Access Compliance Report

Public Rights-of-Way

(Curb Ramps)

Intersection ID: 44540	Main Street: NEAL_RD	Cross Street: UNIVERSITY_CITY_BV	Location: N
ADA ID: 4D087D9281D4	Ramp Type: Perp	Initial Pass/Fail: Fail	Overall Compliance: No
Severity Score: 8.75			
Codes/Mitigation Info/Possible Solution		Field Measurements/Component Compliance

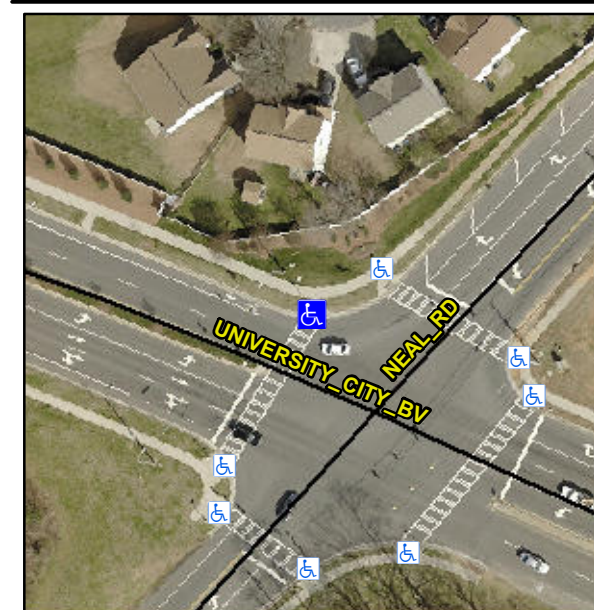
Not Found, R304.5.1

Compliance	Description	Data	Compliance	Description	Data
N/A	Ramp Length (in)	94.0	Yes	Ramp Slope (%)	6.0
No	Ramp Width (in)	47.5	Yes	Ramp XSlope (%)	0.1
N/A	Flare Type LT	N/A	N/A	Flare Type RT	N/A
N/A	Flare Slope LT (%)	N/A	N/A	Flare Slope RT (%)	N/A
N/A	Flare Traversable LT?	N/A	N/A	Flare Traversable RT?	N/A
N/A	Landing Length (in)	N/A	N/A	DWS Provided?	N/A
N/A	Landing Width (in)	N/A	N/A	DWS Contrast?	N/A
N/A	Landing Slope (%)	N/A	N/A	DWS Length (in)	N/A
N/A	Landing X Slope (%)	N/A	N/A	DWS Full Width?	N/A
N/A	Landing Curb? (Y/N)	N/A	N/A	DWS Offset (in)	N/A
N/A	Shared Landing?	N/A			
N/A	Gutter Ponding?	N/A	N/A	Gutter Slope (%)	N/A
N/A	Gutter Lip Ht (in)	N/A	N/A	Gutter X Slope (%)	N/A
N/A	Painted X Walk1?	Yes	N/A	Painted X Walk2?	N/A
	X Walk 1 Direction	To SW		X Walk 2 Direction	N/A
N/A	X Walk 1 Width (in)	103.0	N/A	X Walk 2 Width (in)	N/A
	X Walk 1 Slope (%)	1.1		X Walk 2 Slope (%)	N/A
	X Walk 1 X Slope (%)	1.2		X Walk 2 X Slope (%)	N/A

N/A	Ramp inside XWalk1?	Yes	N/A	Ramp inside XWalk2?	N/A
	Road Slope (%)	N/A	N/A	Clear Space?	N/A
	Road X Slope (%)	N/A	N/A	Clear Space to XWalk (in)	N/A
N/A	Any Obstructions?	N/A	N/A	Storm Grate/Utility Hazard?	N/A
	Obstruction Type			Storm Grate/Utility Type	
		N/A			N/A
		Yes		Surface Condition? (G/P)	Good

Remove & Replace Entire Ramp.
